## CITY OF MOUNTAIN VIEW

ENVIRONMENTAL PLANNING COMMISSION  
STAFF REPORT  
WEDNESDAY, MARCH 2, 2022

- 5.1 **Study Session to Discuss a Request for a Planned Community Permit, Development Review Permit, and Heritage Tree Removal Permit to Construct a New 80,000 Square Foot Office Building, a New Parking Structure with Four Levels Above Grade and Two Levels Below, and Minor Building Modifications to an Existing Two-Story Office Building to Remain On-Site, Including a Request for Transfer of Development Rights as Part of the Los Altos School District TDR Program at 189 North Bernardo Avenue**

Figure 2: Site Plan

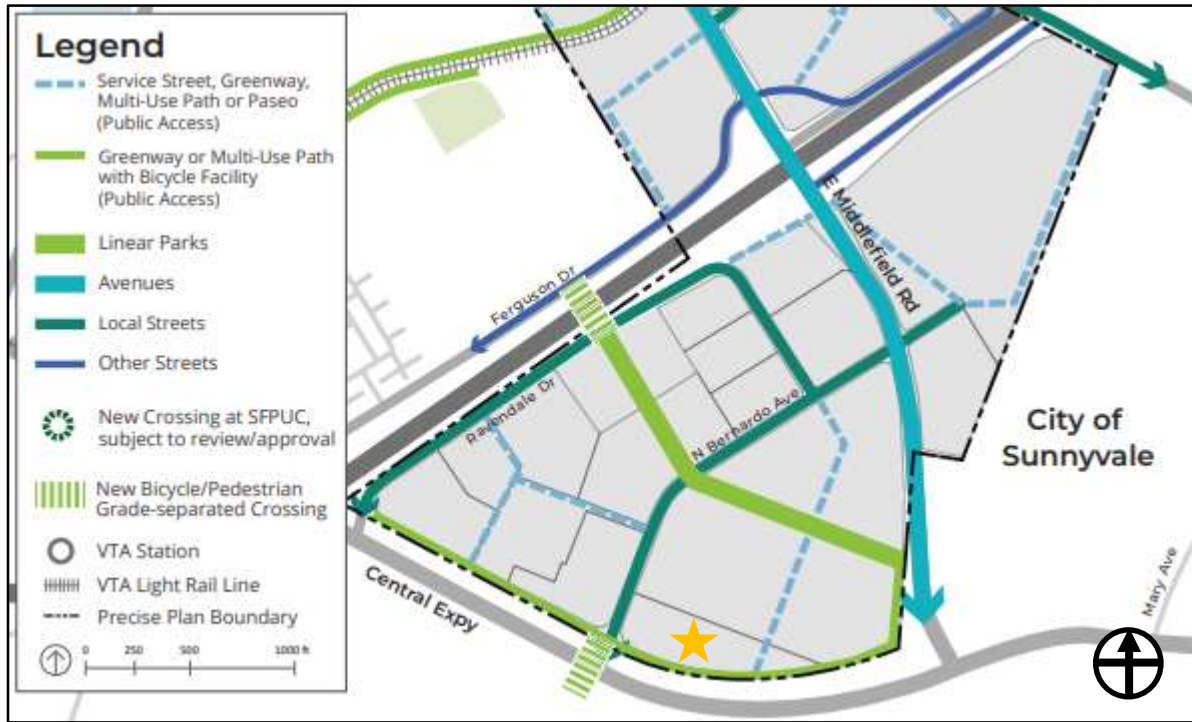
The DRC discussed the proposed site plan at length and provided many detailed recommendations. While the DRC generally supported the site layout, given the project and site’s constraints, the DRC indicated site plan refinement should be prioritized, including the following recommendations, to better comply with the intent of the EWPP and improve the projects’ design:

- Continue to work with staff to study all opportunities to preserve or relocate healthy, mature trees, especially native species. Tree replacements should prioritize large, canopied species.
- Increase the office building and garage setbacks from the multi-use path to allow for amenities, improved landscape buffers along the path, and tree preservation. If proposed buildings cannot be fully set back along the entire length of the multi-use path, study options, such as ground-floor-only setbacks or limited ground-floor setbacks at periodic intervals along the path.

- Create strong visual and/or physical connections between the various publicly accessible open spaces, particularly those located at the far corners of the property. Special attention should be given to connecting the open spaces to the multi-use path and to addressing design features that currently constrain access from the multi-use path to more internal public access areas.

- Design and program the publicly accessible areas to create a mix of experiences and purposes.
- Extend the special paving material and pedestrian-oriented design elements across the driveway to extend the north/south paseo to the adjacent site (north) and complete the future connection. Continue to work with staff to study options to soften the appearance of large pavement areas in the emergency vehicle turnaround area.

- Include wayfinding signage for the public-use areas of the private property.
- Ensure proposed buildings are designed to engage the open space/circulation pathways they front, as discussed in more detail below.

***EPC Question No. 1: Does the EPC support the proposed exceptions to the EWPP development standards for the multi-use path and paseo and/or have any additional comments on the project site plan?***

**Figure 4: Circulation Plan**

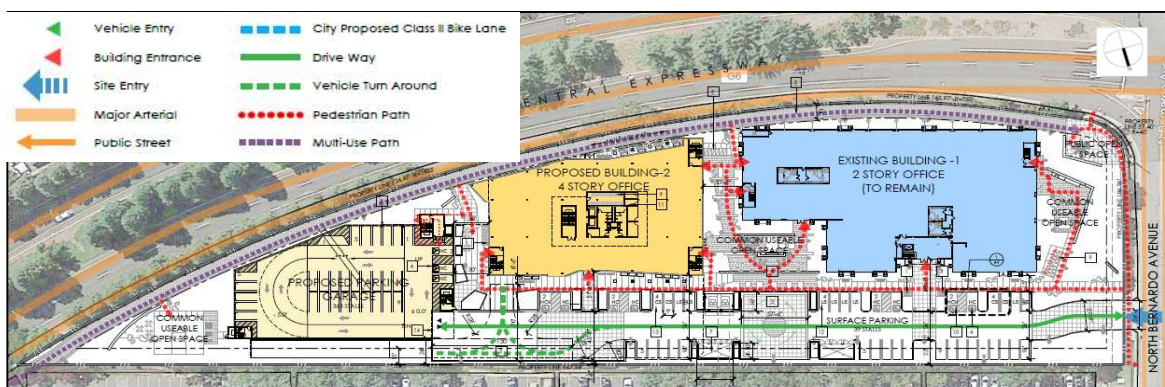
The proposed circulation plan (Figure 4) locates the multi-use plan along Central Expressway and the north-south paseo between the proposed office building and parking garage, consistent with the locations illustrated in the EWPP.

Due to the existing development to remain, the project site’s irregular shape, and the increased intensity through the TDR program, the multi-use path and the north-south paseo do not meet some of the development standards in the EWPP. The project is seeking exceptions to some multi-use path and paseo standards as outlined in Table 1 below.

**Figure 5: Partial Tree Plan**

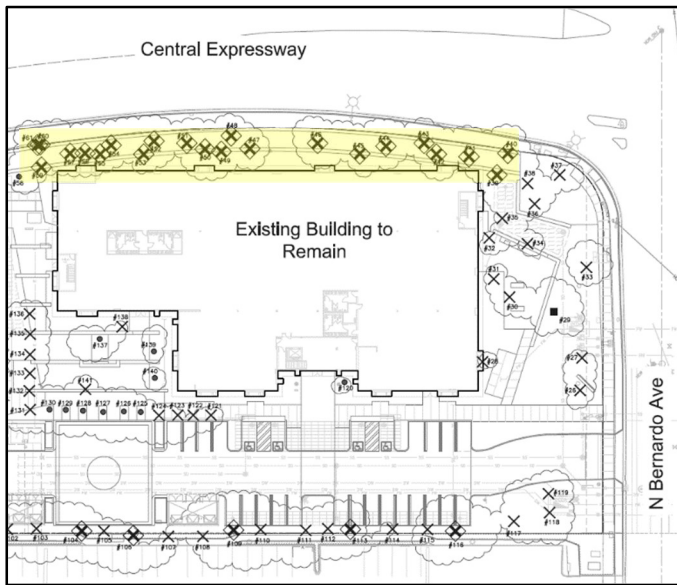
Twenty-two (22) of the Heritage trees proposed for removal are located along Central Expressway and are proposed for removal due to conflict with the multi-use path (See the yellow highlighted area in Figure 5). Nineteen (19) of these trees are healthy. Staff has identified six of the healthy trees for potential preservation if further studies determine innovative design of the multi-use path along Central Expressway is feasible. The potential future design would involve meandering the path decreasing the width of the path at certain locations.

Many of the trees in question, highlighted in Figure 5, would likely be removed in the planned Bernardo Undercrossing project.

***EPC Question No. 2: Does the EPC support studying minor changes to the building/garage footprints, decreased vehicular parking, and further exceptions to the multi-use path design to preserve trees as identified by staff and/or have any additional comments on the proposed tree plan?***
